ADOPTION DE PUBLICATIONS DE L'OHI
SPECIFICATIONS DE PRODUITS BASEES SUR LA S-100
PHASE 1 – S-101, S-102, S-104, S-111, S-129

**MEMBER STATES' RESPONSES TO IHO CL 39/2024 AND COMMENTS
FROM THE WORKING GROUP and PROJECT TEAM CHAIRS, IHO SECRETARIAT**

S-101, Ed. 2.0.0	Operational Product Specification
-------------------------	--

Figure 4-10 – Dataset loading – scenario 4

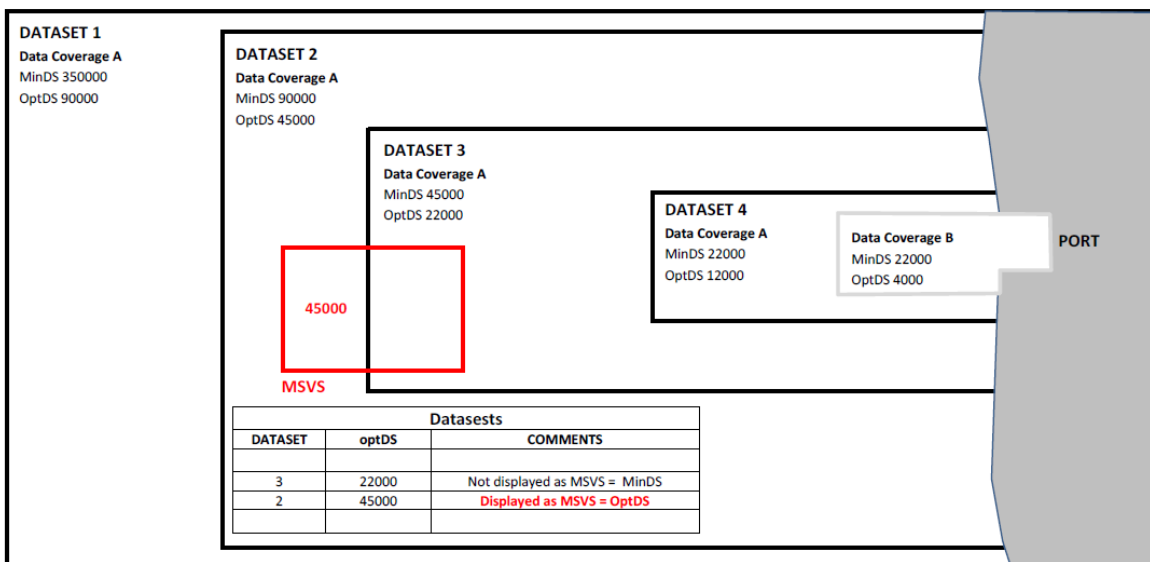
- 3) Product Specification - Add the attached Diagram to the end of Section 4.7.2 as a new Figure 4.10 and amend 2nd paragraph to read 'Figures 4-7 to 4-10 below are ...!'

Please note that all other Figures in the PS will have to increase their number by one.

The S-101PT Chair and IHO Secretariat thank Australia for their comments. These proposed changes have been agreed for correction (point 1) and clarification (points 2 and 3) as they enhance the guidance already included. The proposed new Figure 4-10 for the S-101 Main document has been included as Figure 4-9 as this is a better fit within the order of the Figures 4-7 to 4-10 in regard to Mariners' Selected Viewing Scale (MSVS). The changes have been applied for the final operational Edition 2.0.0 of S-101.
